INTRODUCTION

by Andrew A Burbidge

Department of Conservation and Land Management, Western Australian Wildlife Research Centre,
P.O. Box 51, Wanneroo, W.A. 6065.

CALM decided to prepare a review of the ERMP for the EPA; this publication constitutes that submission. The ERMP does not show the full extent of disturbance that will be caused by the proposed project. It gives an area of land that will be disturbed at some stage of the project life of 1 150 ha within the proposed conservation reserve but this does not include the full area of disturbance since it ignores edge effects and other possible damage to vegetation such as from groundwater drawdown and air pollution. In order to assess better the possible impact of the proposed project, CALM developed an impact zone of 1 474.5 ha, which included a 100 m buffer strip around all cleared or flooded areas.

Figure 1.1

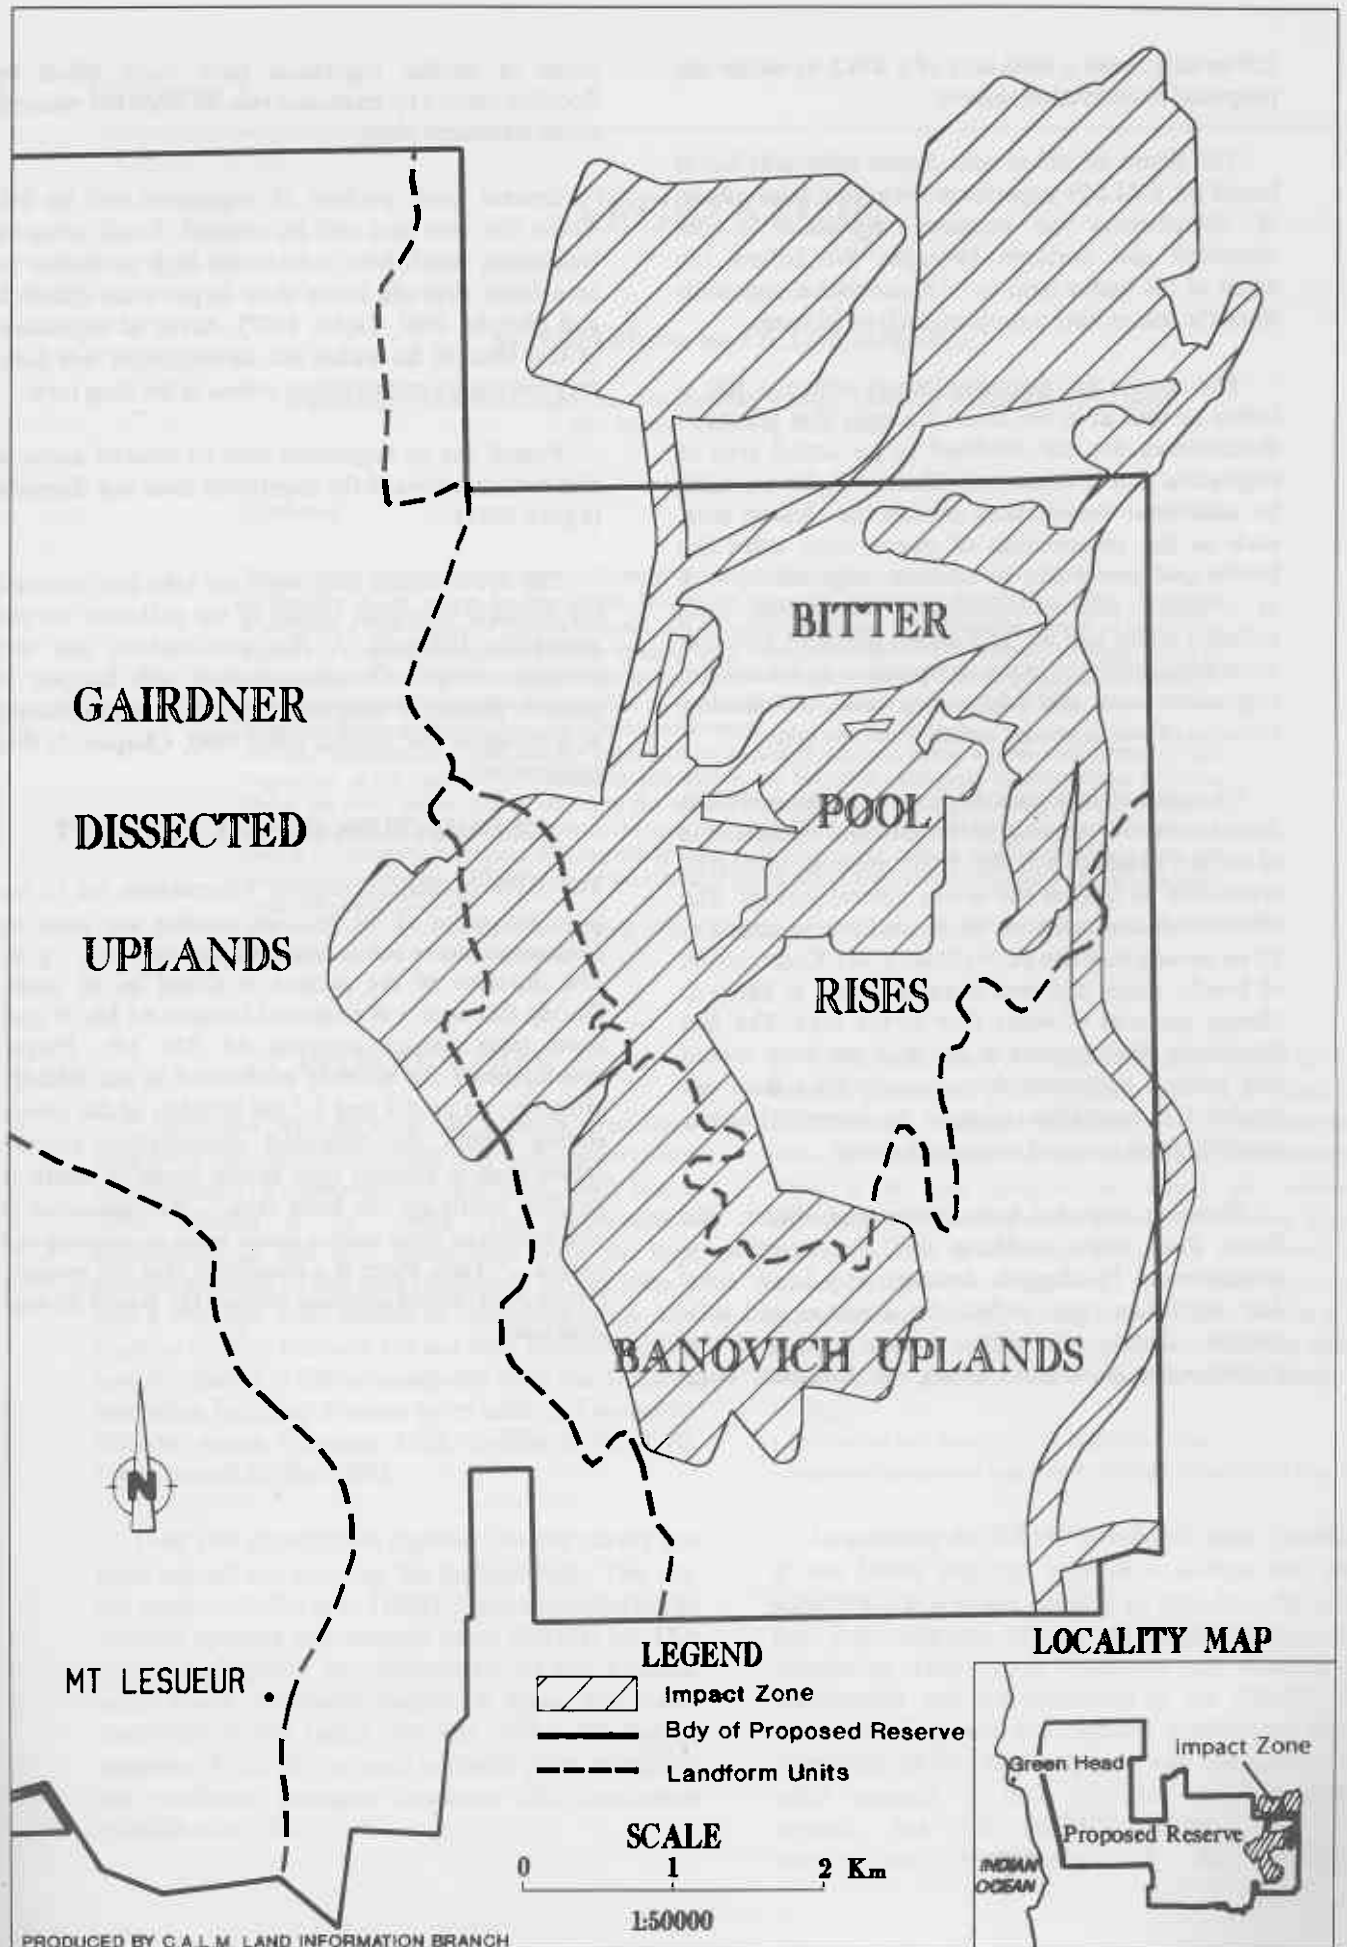
In order to assess better the possible impact of the proposed project, CALM developed a map based on ERMP Figure 7.4 (but with the access road extended to the south as shown in ERMP Figure 5.1) plus a 100 m buffer strip around all cleared or flooded areas (Figure 1.1). A Geographic Information System was used to make calculations of impact, for example, on the different landforms and vegetation types. Calculations of the area disturbed, including the

100 m strip, gave a total area of 1 474.5 ha within the proposed conservation reserve.

The figure of 100 m was chosen arbitrarily but is based on CALM's experience with long term effects of disturbances on remnant vegetation in the wheatbelt and northern kwongan. We believe the width of the buffer strip to be conservative, especially since the mines have a projected life of 30 years.

The reason for assessing impact within a 100 m buffer as well as in the cleared area is that effects of disturbances are not confined to an actual area of vegetation that is destroyed. There will, for example, be additional disturbances outside the cleared area, such as the construction of power lines, extra fire breaks and gravel pits. In addition, edge effects such as changed micro-meteorological conditions, dust, polluted water and air, and added nutrients all cause detrimental changes in the composition and density of vegetation near the edge of a road or clearing. Invasion of weeds occurs mainly from the edge.

The 100 m buffer strip does not take into account the possible extensive effects of air pollution on the vegetation (Chapter 2, this publication) nor the extensive, major disturbances that will happen if dieback disease (*Phytophthora* species) is introduced as a result of the project (Hill 1990, Chapter 5, this publication).
